# Recall Campaign Bulletin

RECALL CAMPAIGN #B.181  
Incorrect Specification Camshaft

**MARINA**

July, 1973

SERVICE PROCEDURERECALL CAMPAIGN B.181 - AUSTIN MARINA CAMSHAFT, PART #88G-303CHECKING PROCEDURE

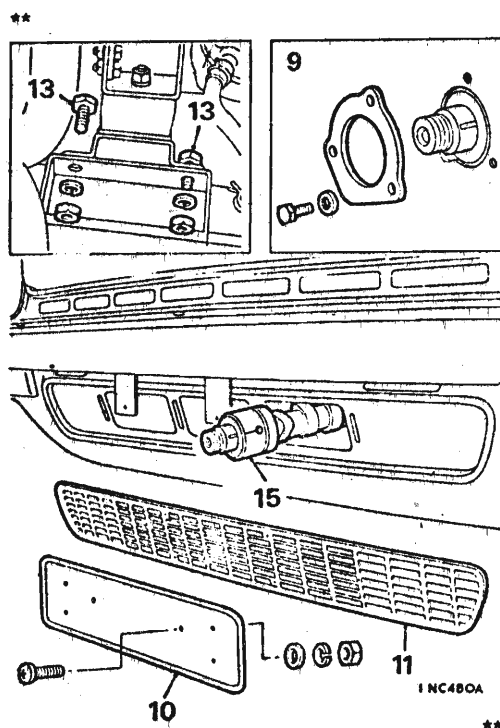
1. Engine cold, set crank to T.D.C. number 4 cylinder firing.
2. Set number 7 rocker (numbering from front) to 0.044".
3. Rotate engine 360 degrees backwards to T.D.C.
4. If all clearance taken up on number 7 rocker, camshaft is O.K. Reset number 7 rocker to 0.013" (12-29-48) and release car.
5. If 0.015" gap exists on number 7 rocker, wrong camshaft is fitted. Change camshaft.

1. Drain the cooling system. 26.10.01.
2. Remove the radiator. 26.40.01.
3. Remove the rocker shaft. 12.29.54.
4. Remove the distributor drive shaft. 12.10.22.
5. Remove the tappets. 12.29.57.
- 6.\*\*Remove the fuel pump. 19.45.08.
7. Remove the timing gear cover. 12.65.01.
8. Remove the timing chain and gears. 12.65.12.
9. Remove the three screws and shakeproof washers retaining the camshaft locating plate.
10. Remove the number-plate.
11. Drill out the rivets and remove the air intake grille.
12. Support the engine.
13. Remove the bolts securing the engine mountings to the chassis.
14. Lower the engine until the camshaft aligns with the air intake grille mounting aperture.
15. Withdraw the camshaft.\*\*
